Access Compliance Report

Public Rights-of-Way

Intersection ID: 21949	Main Street: SHARON_VIEW_RD	Cross Street: SUTTON_SPRINGS_RD	Location:	N
ADA ID: 3FE320EFE492	Ramp Type: Perp	Initial Pass/Fail: Fail	Overall Compliance: No	Severity Score: 12.5

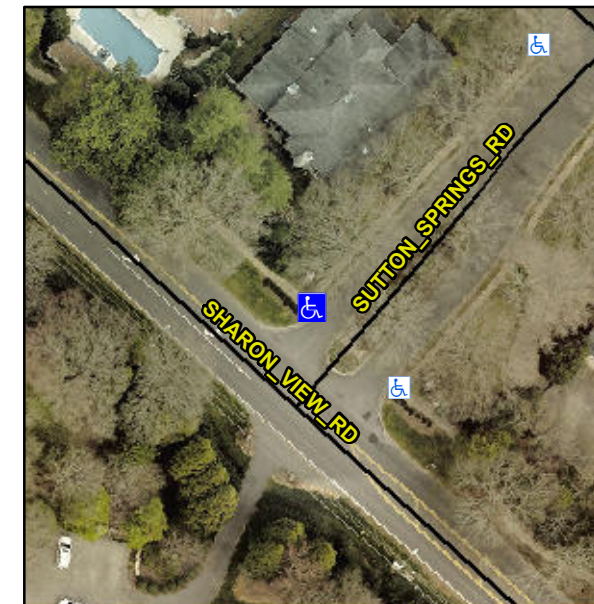
R304.2.2

Compliance	Description	Data	Compliance	Description	Data
N/A	Ramp Length (in)	61.0	No	Ramp Slope (%)	8.5
Yes	Ramp Width (in)	60.0	Yes	Ramp XSlope (%)	0.5
N/A	Flare Type LT	N/A	N/A	Flare Type RT	N/A
N/A	Flare Slope LT (%)	N/A	N/A	Flare Slope RT (%)	N/A
N/A	Flare Traversable LT?	N/A	N/A	Flare Traversable RT?	N/A
N/A	Landing Length (in)	N/A	N/A	DWS Provided?	N/A
N/A	Landing Width (in)	N/A	N/A	DWS Contrast?	N/A
N/A	Landing Slope (%)	N/A	N/A	DWS Length (in)	N/A
N/A	Landing X Slope (%)	N/A	N/A	DWS Full Width?	N/A
N/A	Landing Curb? (Y/N)	N/A	N/A	DWS Offset (in)	N/A
N/A	Shared Landing?	N/A			
N/A	Gutter Ponding?	N/A	N/A	Gutter Slope (%)	N/A
N/A	Gutter Lip Ht (in)	N/A	N/A	Gutter X Slope (%)	N/A
N/A	Painted X Walk1?	No	N/A	Painted X Walk2?	N/A
	X Walk 1 Direction	To SE		X Walk 2 Direction	N/A
N/A	X Walk 1 Width (in)	N/A	N/A	X Walk 2 Width (in)	N/A
	X Walk 1 Slope (%)	1.2		X Walk 2 Slope (%)	N/A
	X Walk 1 X Slope (%)	3.0		X Walk 2 X Slope (%)	N/A

Remove & Replace Entire Ramp.
